ADDENDUM 002
Barrett Station Vehicle Exhaust Removal Project
Request for Bid 9-130806TV

FAN EXHAUST DETAIL

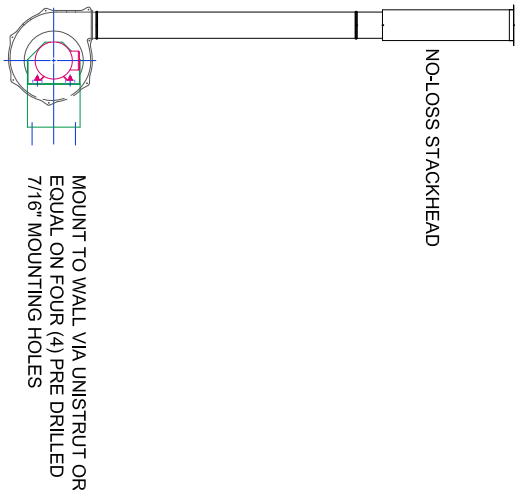
Ductwork Type and Materials: UMC Class 2 or SMACNA Class II product conveying duct, meet or exceed criteria for construction and performance as outlined in Round Industrial Duct Construction Standards, SMACNA. Materials of construction unless otherwise specified for all ductwork and fittings shall be a minimum G-90 galvanized sheet metal (ASTM A653/A653M). External Ductwork: Sized for the exact inlet and outlet of the exhaust fan blower. A 6" no-loss stackhead part number 3204-0600 shall be used for the exhaust stack.

FAN ORTHOGRAPHICS

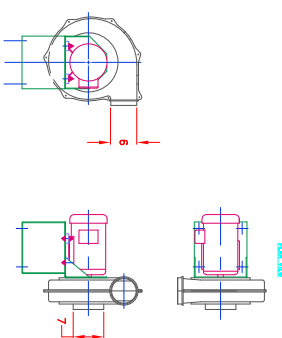
C. The exhaust fan on the North system must be the Fume-A-Vent PB14-3-3-T series and the South system shall have a model PB15-5-3-T or equivalent.

HOSE REEL ORTHOGRAPHICS

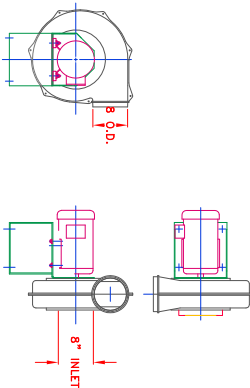
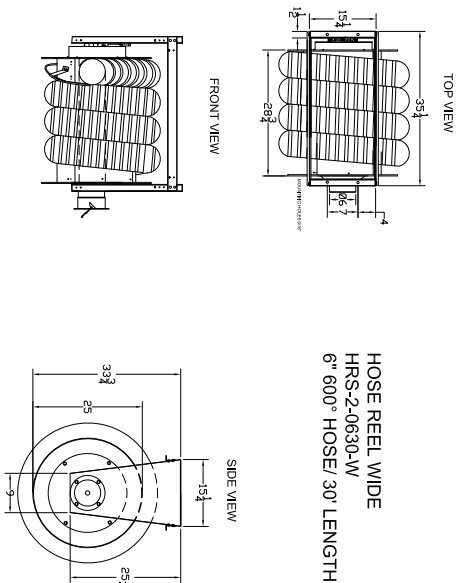
1. Provide 10 hose reels with 6" diameter x 30' long exhaust hose model HRS-2-0630-W or equivalent. Hose reels will be mounted to ceiling purlins and cross members using unistrut.
